*As-Built / Proposed Revisions
of Secondary (West) Façade
Window Configuration for
381 West End Ave*

*presented to:
Landmarks Preservation Commission
June 17, 2025*

presented by: Altin Batska, XXII Eleven LLC

381 West End Ave

Visibility and Architectural Intent

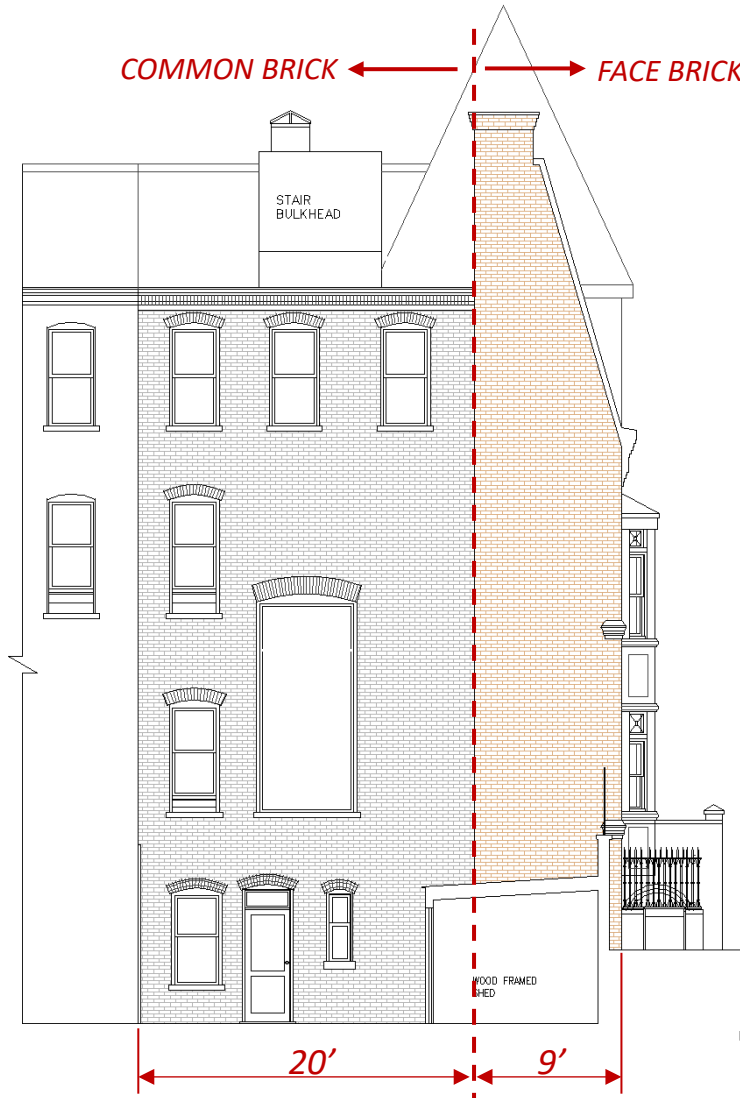
- The secondary (west) façade is *intentionally* designed in two distinct sections: Face Brick, and Common Brick.
- This deliberate differentiation clearly signals a *hierarchy of visibility* and *architectural intent*.
- Common brick section of the West Façade is *transiently visible*
- Window configuration seems a *function of interior layout*

LPC 2023 Revised Rules
Section 2-14(h)(5):

... a secondary façade is “minimally visible” if the façade is seen at such an angle that the configuration of the windows cannot be seen or is very difficult to discern, or *only a small portion of the façade is seen through a gap in the streetwall* and is visually disconnected from the primary façade of the building.

Visibility and Architectural Intent

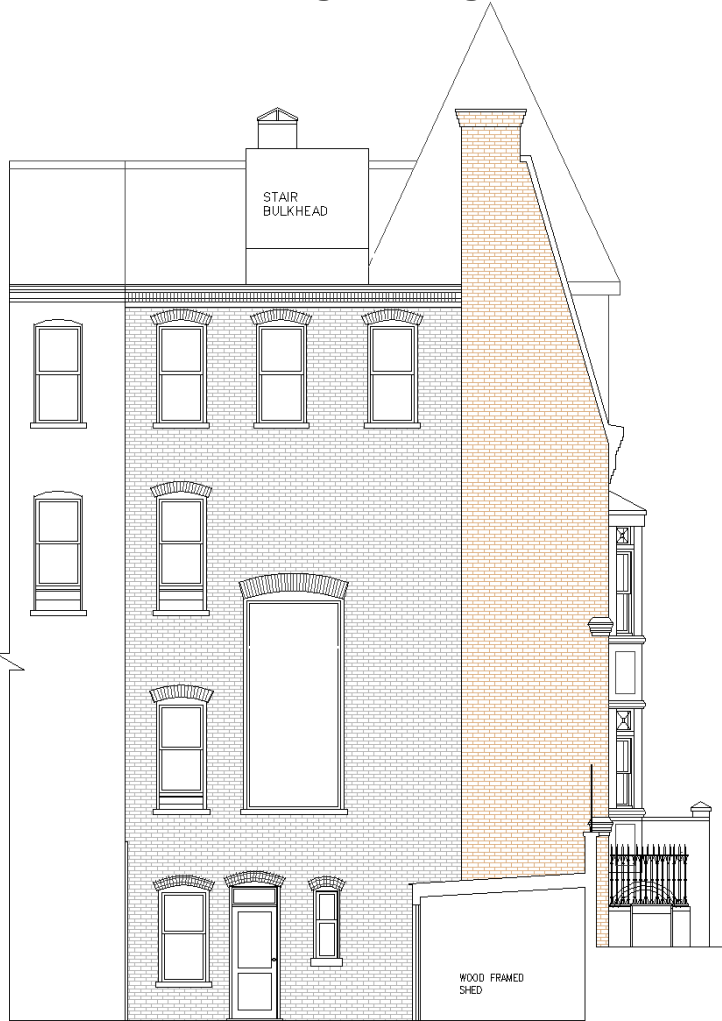
- The secondary (west) façade is *intentionally* designed in two distinct sections: Face Brick, and Common Brick.
- This deliberate differentiation clearly signals a *hierarchy of visibility* and *architectural intent*.
- Common brick section of the West Façade is *transiently visible*
- Window configuration seems a *function of interior layout*

LPC 2023 Revised Rules
Section 2-14(h)(5):

... a secondary façade is “minimally visible” if the façade is seen at such an angle that the configuration of the windows cannot be seen or is very difficult to discern, or *only a small portion of the façade is seen through a gap in the streetwall and is visually disconnected from the primary façade of the building.*

Secondary (West) Façade – As-Built

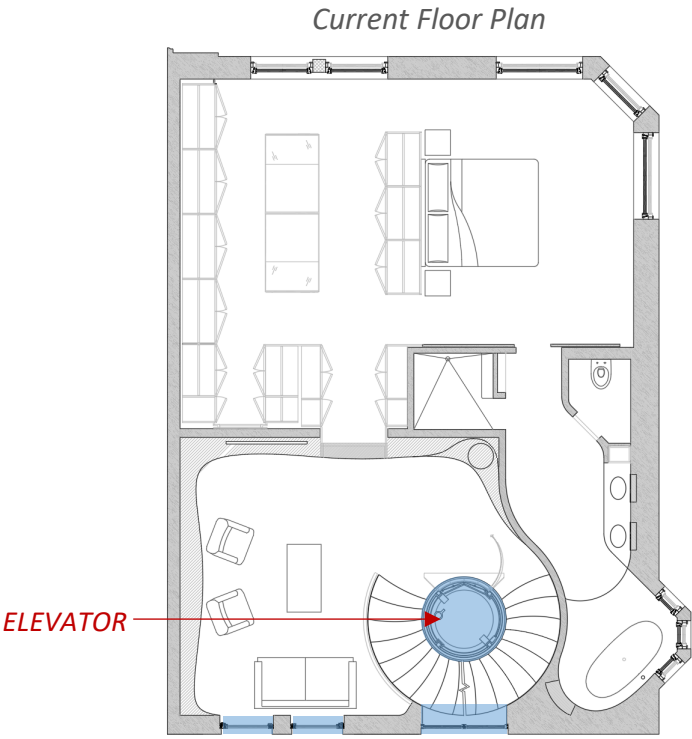
2025 – As-Built / CB7 Approved

344 SF Openings

Window column aligned with center of elevator

Relocation of Elevator triggered a new interior layout, which in turn triggered a need for a revised West Façade window configuration

Currently Approved Elevation

380 SF Openings

Proposed (rendering)

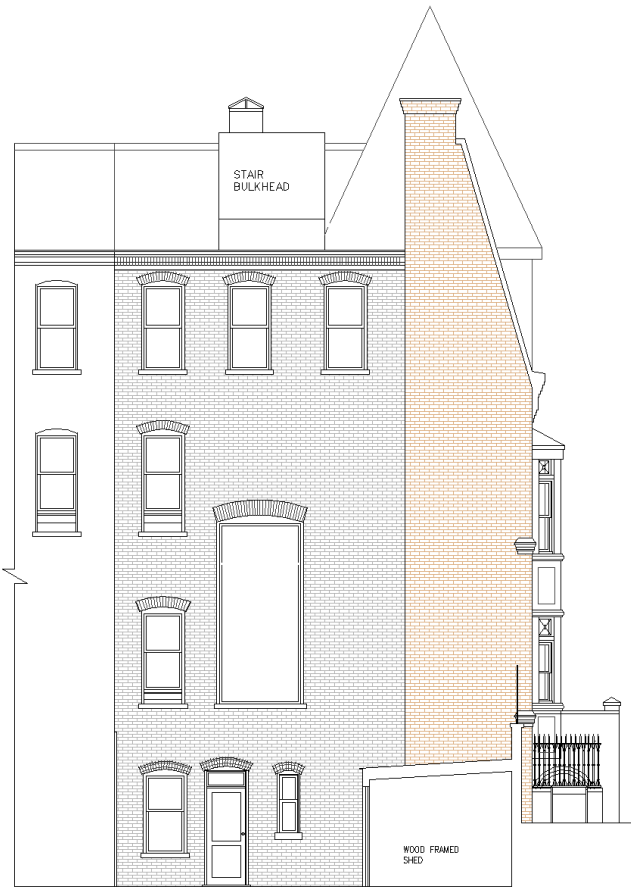
We respectfully request LPC approval of this as-built / proposed layout based on the following:

- *The proposed layout maintains architectural intent and hierarchy of visibility*
- *Consistent with original design the window configuration is a function of interior layout*
- *The proposed bulkhead revision maintains the original roof line and brings this layout much closer to the currently approved version.*
- *The limited and transient visibility of the common brick section of the Secondary Façade does not compete with the primary facades in texture, color or composition.*
- *Proposed change improves on as-built elevation which CB7 approved*
